**RE: 4-6 Bligh Street, Sydney
 Planning Proposal Addendum**

This letter is intended as an addendum to the Planning Proposal which was considered as part of the Rezoning Review process and is intended to address the concerns of Council as raised in the email from Andrew Thomas, A/ Director City Planning, Development & Transport, dated 22 January 2018 (**Attachment A**), and the corresponding meeting held between the applicant and City of Sydney staff on 30 January 2018 (Meeting minutes provided at **Attachment B**).

Figure 1 Compliant building envelope SVF Analysis

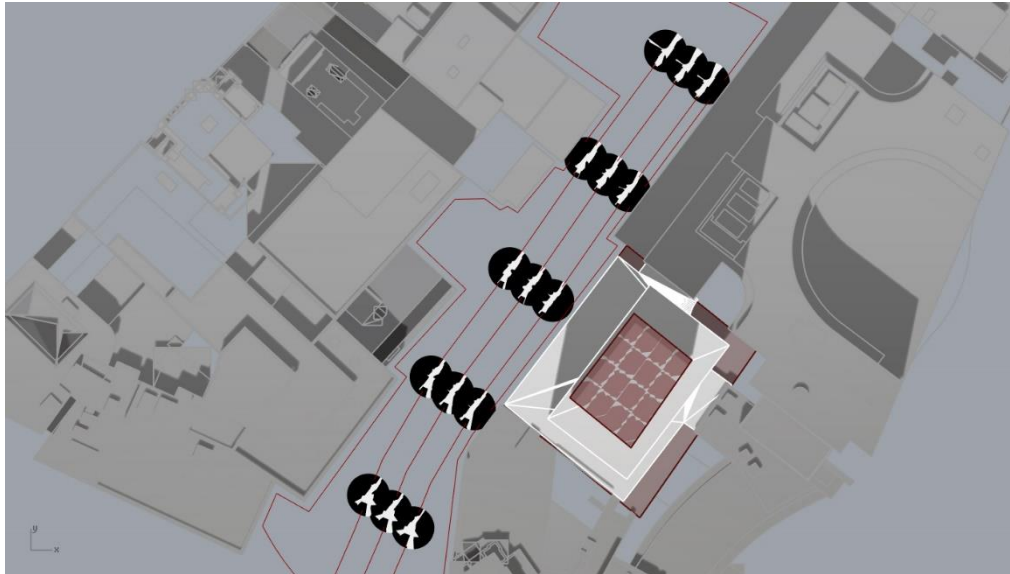
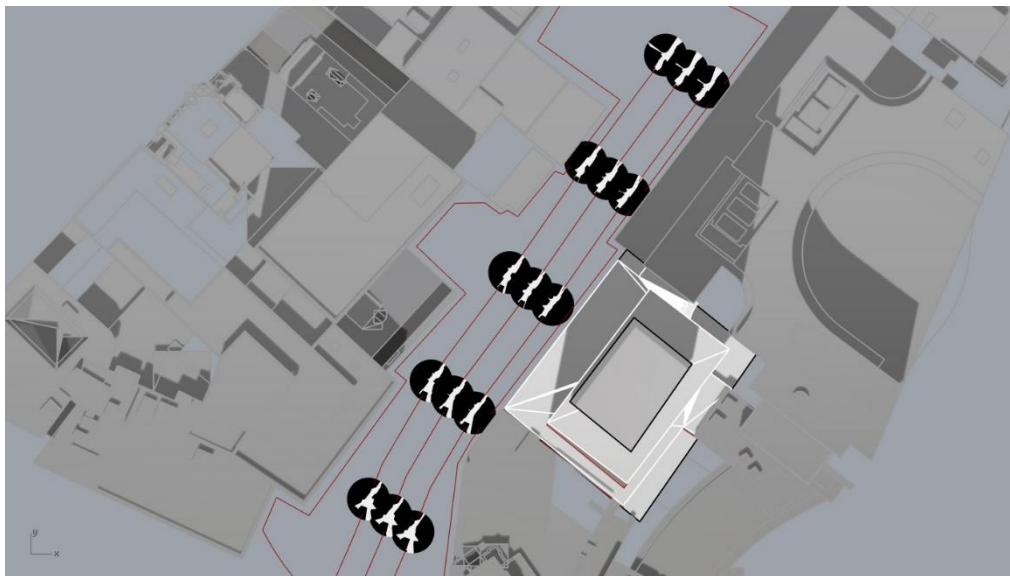
Council had identified that the raster images prepared for the SVF Report were of a low resolution and queried whether a higher resolution analysis would achieve different results. It is noted that the analysis was initially undertaken as a low resolution due to the high volume of analysis points required (3,151) to satisfy Council's proposed methodology. Additional analysis was undertaken at a far higher resolution at 15 locations within Bligh Street as illustrated in Figure 1 and Figure 2 below. The SVF views produced for the compliant and proposed building envelopes at an increased image resolution are provided in Figures 3 to 7 below.

The SVF results for the 15 analysis points at both a high and low resolution are provided in Table 1 and Table 2 below.

While the above results clearly indicate that the resolution of the raster image affects the results of the analysis, the impact on the proposed development are similarly considered to be major and would have a critical impact on project viability.
